[Docket No. 2000-SW-13-AD; Amendment 39-12132; AD 2001-04-13]

Airworthiness Directives; Eurocopter France Model SA.315B, SA.316B, SA.316C, SE.3160, and SA.319B Helicopters

ACTION: Final rule.

Figure 1

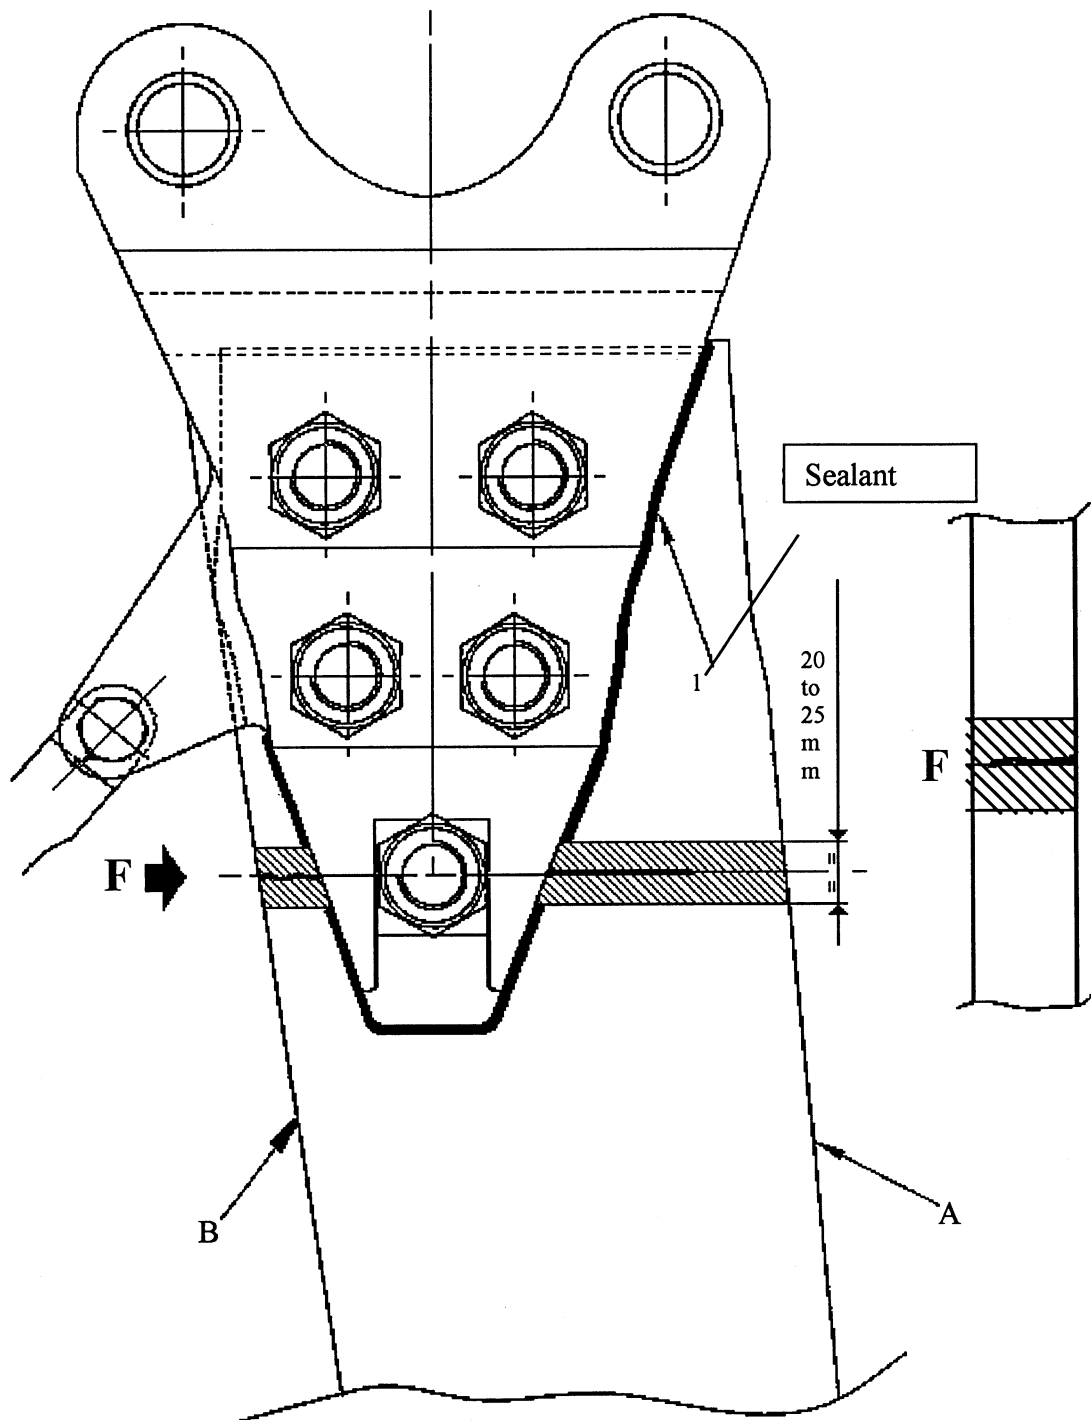
(iii) By either a dye penetrant or eddy current method, inspect each blade along the hatched area indicated in Figure 1, beginning on the blade lower surface, then on the flat section of the trailing edge (B), on the blade upper surface, and then on the flat section of the leading edge (A).

(iv) If a crack is found, replace the blade with an airworthy blade before further flight.
